**November 4, 2025
Addendum #1
FOR IMMEDIATE ATTENTION**

Reference – Invitation for Bid:	IFB #011-0-2026/SB Campus for Student Success Multi-Purpose Room Renovations
For Delivery To:	Newport News Public Schools
Bids Due:	November 14, 2025 at 2:00 PM EST

ADDENDUM NO. 1

Invitation to Bid: IFB #011-0-2026/SB
QE Project Number 42025321 Campus For Student Success Multi-Purpose Room Renovations
Receipt Date/Time: November 14, 2025, at 2:00 PM
Opening Date/Time: November 14, 2025, at 2:00 PM
Subject: Questions and Responses to Bidder questions, Specifications, and Drawings Revisions

Jamb Detail Typical 14/Drawing A104

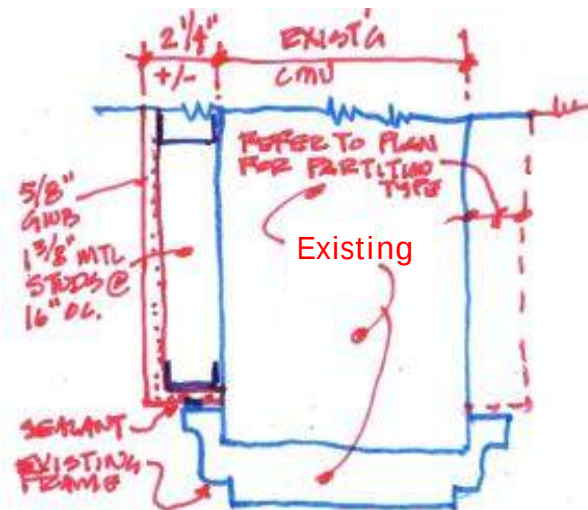
- b) Refer to the attached Supplemental Architectural Sketch SA-1, dated October 31, 2025, that shall add the following door jamb details to drawing A104: ADD detail 14/A104 and 15/A104.

The sketches below shall be added to drawing A104.

DEMOLITION FLOOR PLAN

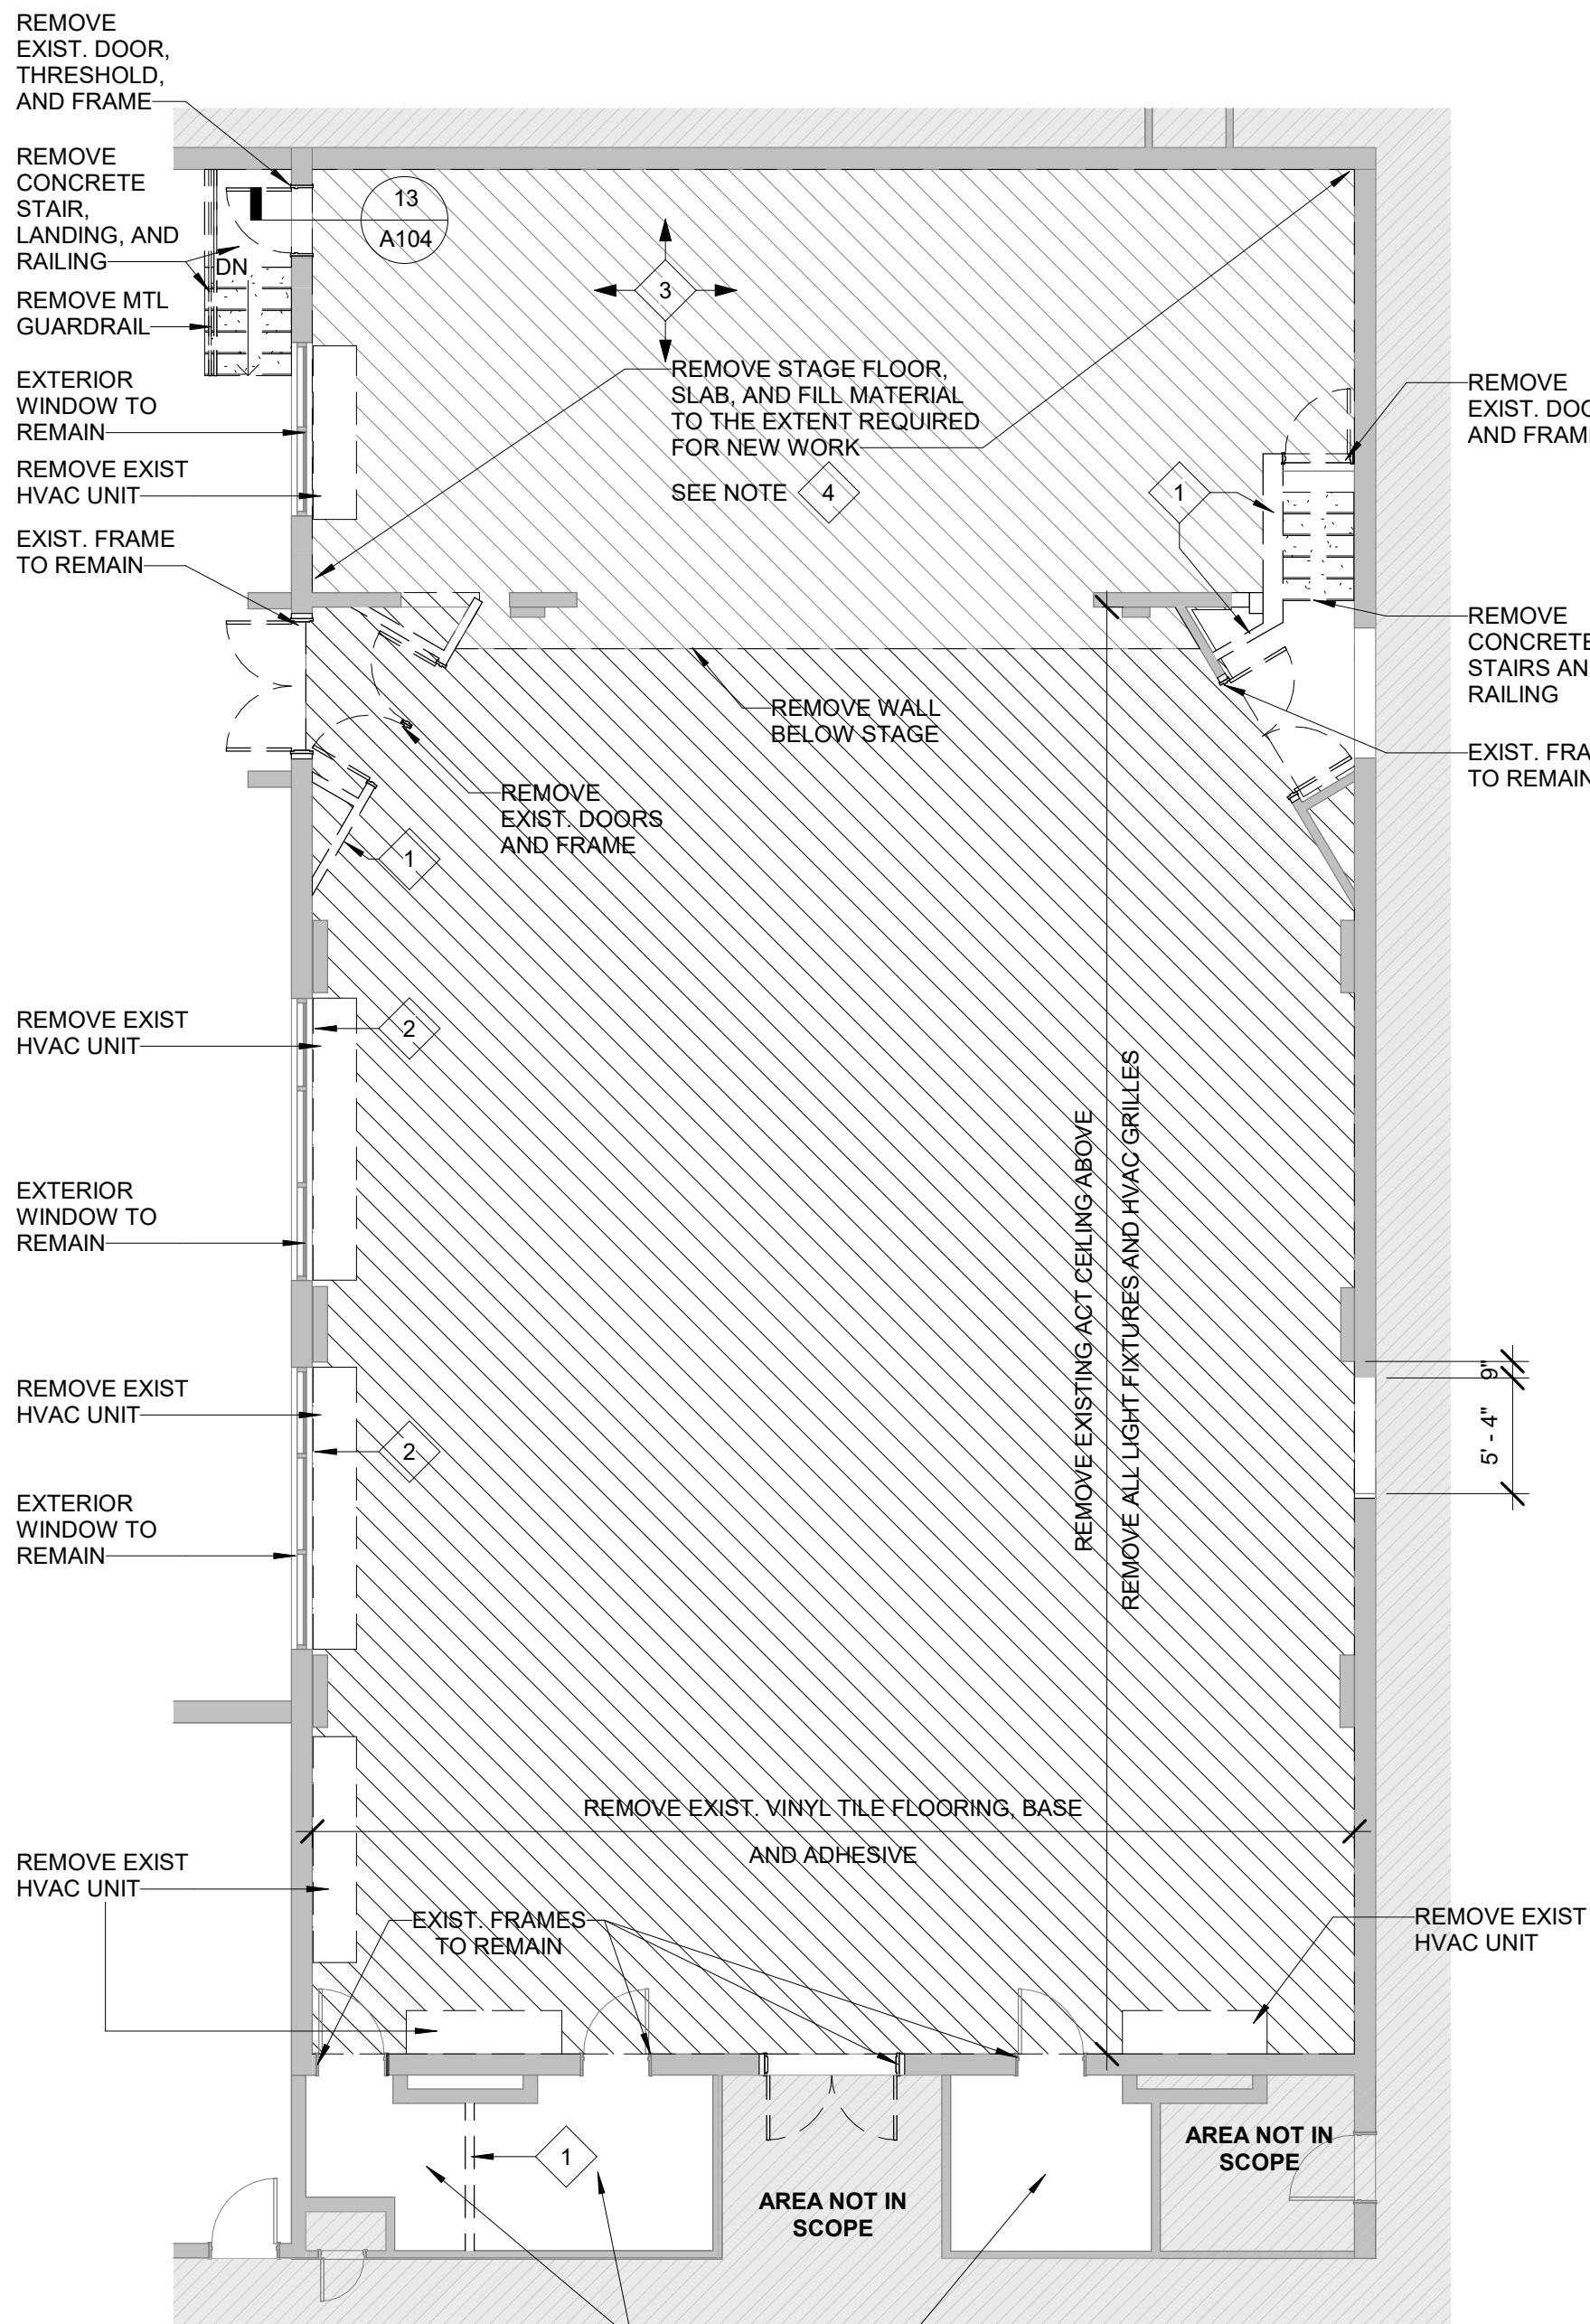
13. QUESTION: A102 Demolition Floor Plan, demo keynote #1 says to remove the six-inch CMU left wall entirely. It & its corresponding right side wall both have 4' wainscot that runs up the step to the stage door. How is the right-side wall wainscot to be treated.

Refer to plan detail 5/A102 for limits of flooring finishes for the new VCT. Assume surface preparation of the existing concrete slab will be required at the wall demolition noted on Demolition Floor Plan 1/A102 (refer to demolition note #1).

Answer: Refer to the revised drawing A102, revised October 31, 2025, that is attached to this Addendum, which provides for additional references to partition type requirements at the area in question.

Answer: The existing canopy roof above the exterior exit stairs (that indicates that the stairs are to be removed on 1/A102), the small canopy roof shall remain as is and shall not be removed.

EXIST. WALL HEAD DETAIL

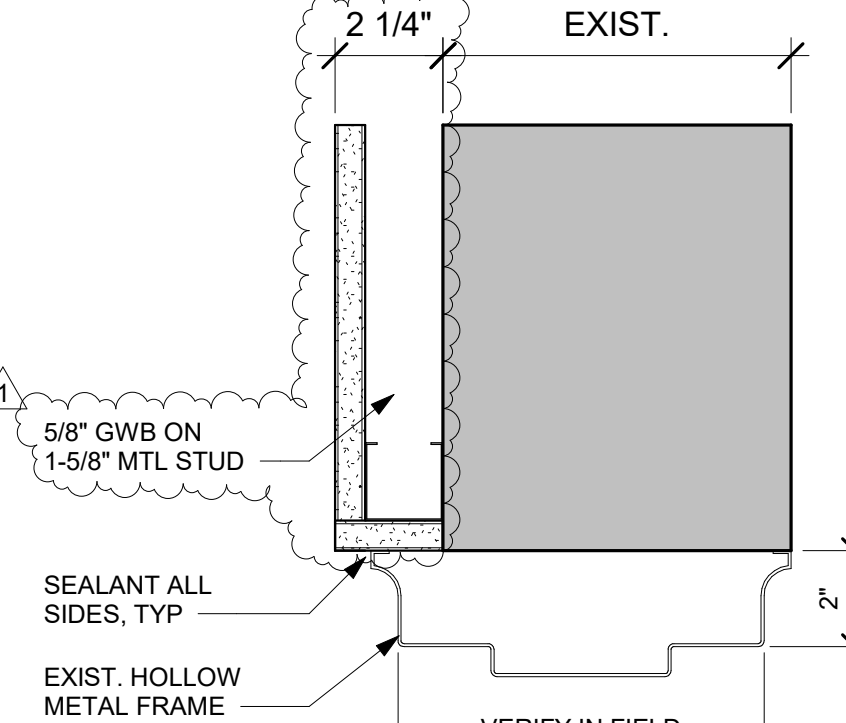
14. QUESTION: Detail 5/A104 Head Detail for 102.2 is listed as existing frame. There is no existing door in this location - correct?

Answer: The door and frame for opening 102.2 consists of a new frame and door conditions. The intent is to have the new frame match the existing profiles of the existing frames within the project.

SF WINDOW JAMB DETAIL (HEAD/SILL SIM)

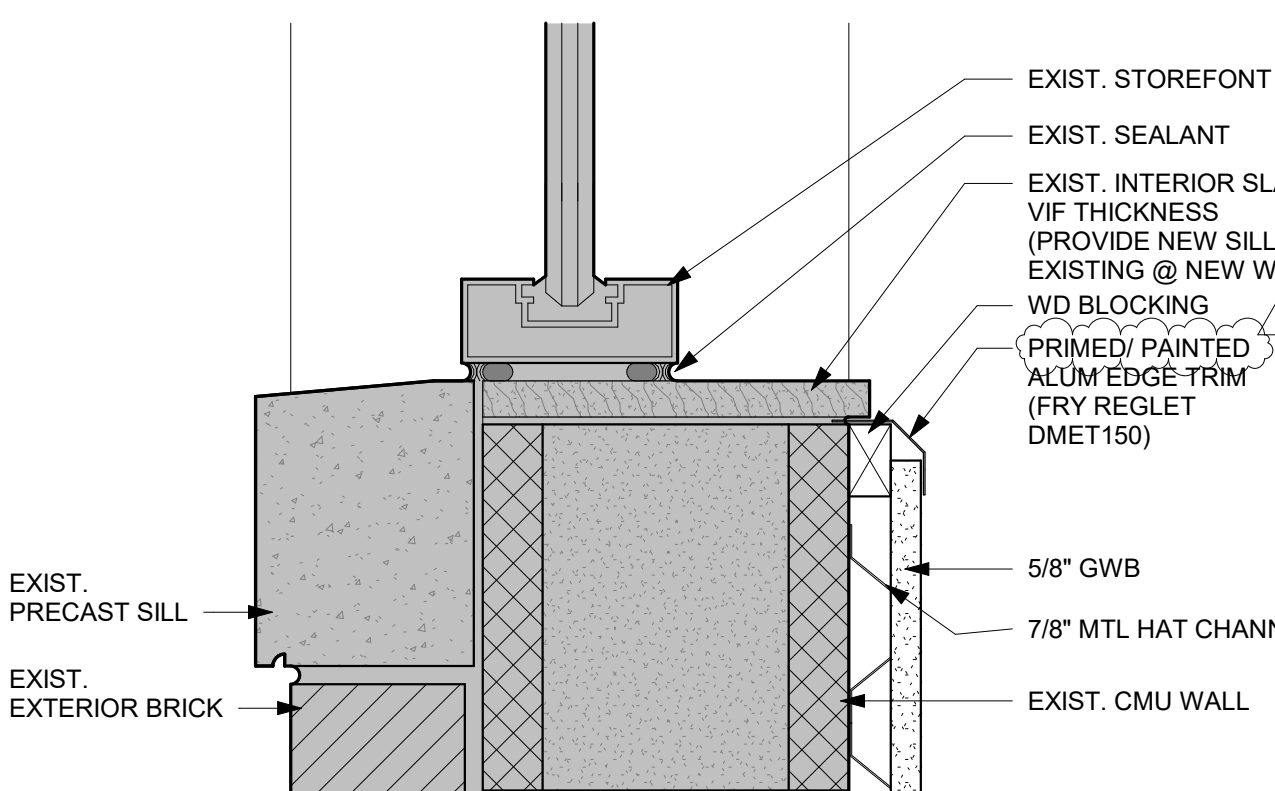
1. QUESTION 1: Drawing A104, Detail 7/A104 – The window detail does not indicate what type of window sill is to be installed. Please provide window sill type and size.

Answer: Please refer to the attached drawing A104, revised October 31, 2025, that is attached to this Addendum, which provides for the revisions noted.
